Exhibit 5

From: ex02@yuandacn.com [ex02@yuandacn.com]
Sent: 3/17/2018 3:17:19 AM
To: Pawel Lepkowski [PLepkowski@WhitestoneCC.com]; James Dearth [JDearth@WhitestoneCC.com]
CC: 谭明华 [charles_tan@126.com]; Phil Carvelas [pcarvelas@WhitestoneCC.com]; Steven Grzic [SGrzic@WhitestoneCC.com]; jason jia [junhuijia2002@yahoo.com]; ex02@yudancn.com [ex02@yuandacn.com]
Subject: Re: Re: CUNY - Building movement @ WT-3 IMPORTANT
Attachments: Attached.pdf

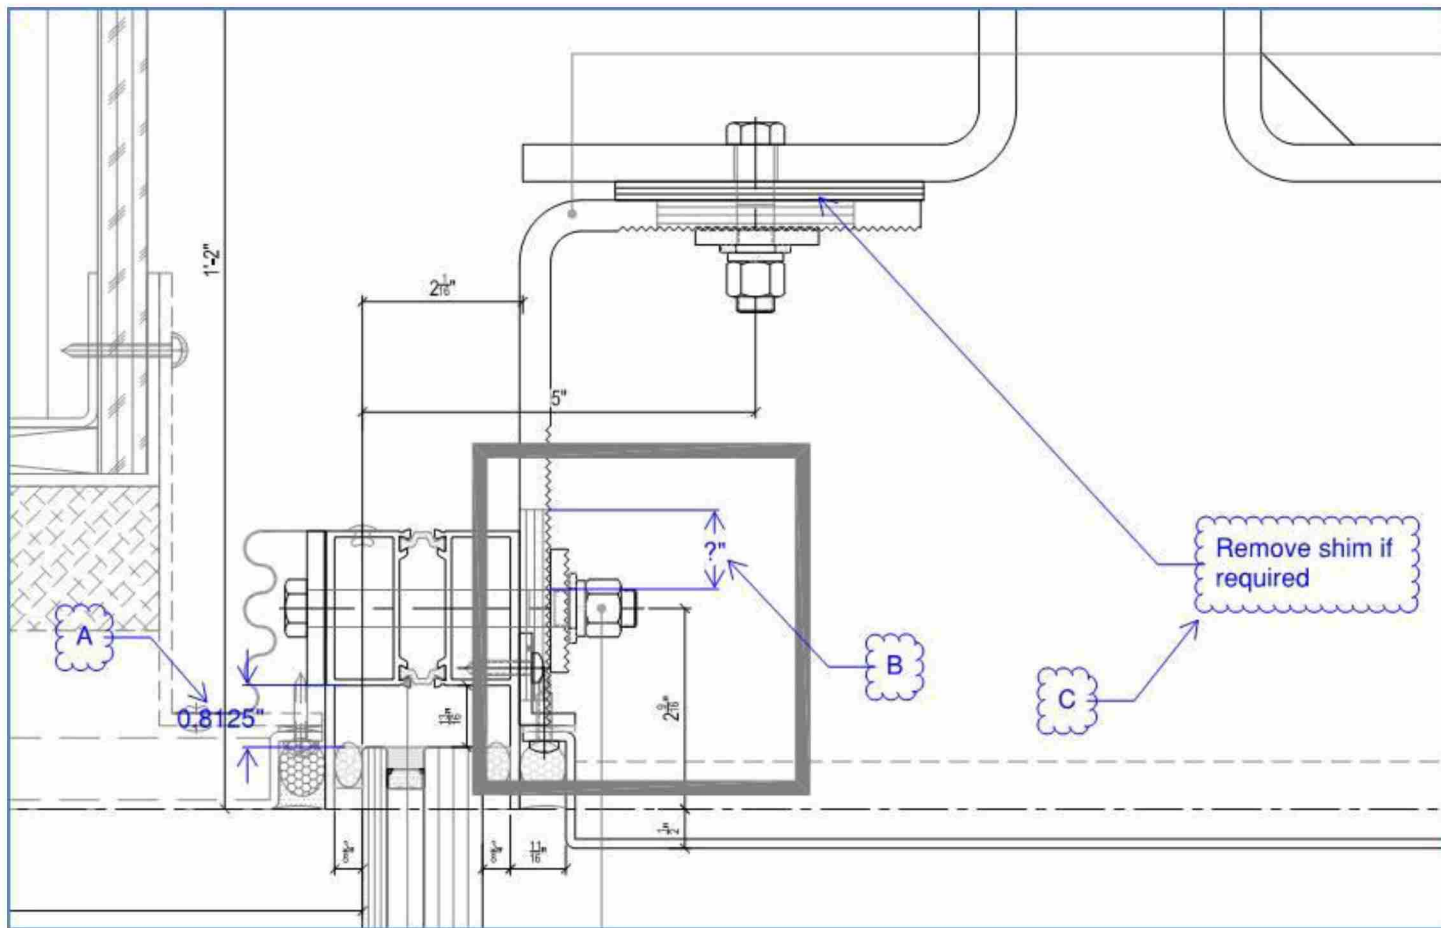
The WT-3 system should only need to absorb about -2.775" of downward vertical movement (from building above) considering that %50 of SDL has already occurred $\{-3.4 - (-1.25/2) = -2.775\}$ – please confirm my understanding is correct.

Theory:

The distance between the top edge of the LS06 bolt and top of the slot in the SG09 bracket would be one of the two limiting factors in absorbing the building movement (see "B"). Once the vertical slot length has been consumed, the system still has 0.8125" of movement capability between the top of glass and inside edge of AL51 extrusion (see "A"). If additional movement is required, depending on actual location of LS06 bolt in relation to the slot in SG09 bracket, some of the PP shim material can be removed between the SG09 and SG37 brackets adding to the capacity for vertical movement.

Yes. Your understanding is correct. As described in RFI 1130, in the worst scenario the building movement would see 2.775" downwards movement maximum theoretically. However, that situation is very extreme, and the movement can be accommodated through the following three locations like you said:

1. To cancel the PP shims between SG09 and SG37, 1/4" movement can be accommodated.
2. Furthermore, some movement can be accommodated through the gap between aluminum channel and glass. The amount can be accommodated can be considered as 1/2" .
3. It can be accommodated through the slot in SG09. Theoretically it can accommodate 3/4" .

In summary, amount can be accommodated can reach 1/4" + 1/2" + 3/4" = 1-1/2" , which is still a lot smaller than 2.775" the maximum building movement.

Therefore, Yuanda suggests to make the slot hole in SG09 longer until 2" to achieve the goal of accommodating building' s movement completely, as indicated in the following drawing.
